DART SERVICE INSTRUCTION

TO AMEND INSTALLATION INSTRUCTIONS D350-607-3 Rev.D,
INSTALLATION INSTRUCTIONS D350-607-4 Rev. C AND
INSTRUCTIONS FOR CONTINUED AIRWORTHINESS ICA-D350-607 REV. 6

REF TCCA STC: SH94-14

A	NEW ISSUE	AJS	14.05.16
REV.	DESCRIPTION	BY	DATE
DESIGN	AJS	DART AEROSPACE LTD	
DRAWN	AJS	HAWKESBURY, ONTARIO, CANADA	
CHECKED		DRAWING NO.	REV. A
MFG. APPR.	N/A	DSI 9699	SHEET 1 OF 2
APPROVED		TITLE	SCALE
DE APPR.		LUG REPLACEMENT	NTS
DATE	14.05.16	COPYRIGHT © 2014 BY DART AEROSPACE LTD	
THIS DOCUMENT IS PRIVATE AND CONFIDENTIAL AND IS SUPPLIED ON THE EXPRESS CONDITION THAT IT IS NOT TO BE USED FOR ANY PURPOSE OR COPIED OR COMMUNICATED TO ANY OTHER PERSON WITHOUT WRITTEN PERMISSION FROM DART AEROSPACE LTD.

FIGURE 1: INSTALLATION OF D4775-041 FWD STRUT

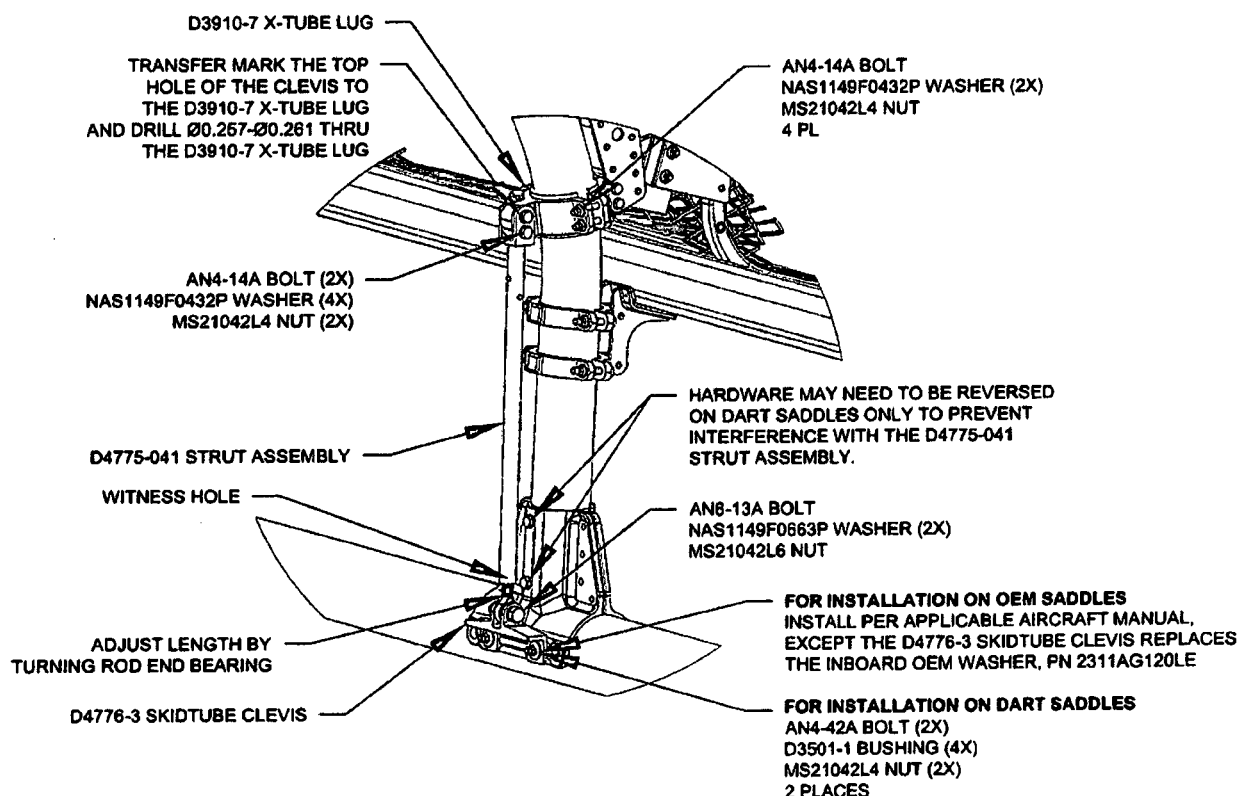
3.1 Substitute the Forward Lower D3910-5 X-Tube Lug with the D3910-7 X-Tube Lug as shown in Figure 1.

3.2 Install the forward D4775-041 Strut Assembly. Transfer mark from the upper hole on the clevis of the D4775-041 Strut Assembly to the D3910-7 X-tube Lug and drill thru the lug $\varnothing 0.257$ - $\varnothing 0.261$ as shown in Figure 1. Touch up chemical conversion coating per MIL-DTL-5541. Check the witness holes located at the bottom end of the D4775-041 Strut Assemblies to ensure that the thread from the rod end extends past the witness hole. Torque MS21042L4/-4 nuts to 50-70 in-lbs (5.7-7.9 N-m). Torque MS21042L6/-6 nuts to 160-190 in-lbs (18.1-21.5 N-m).
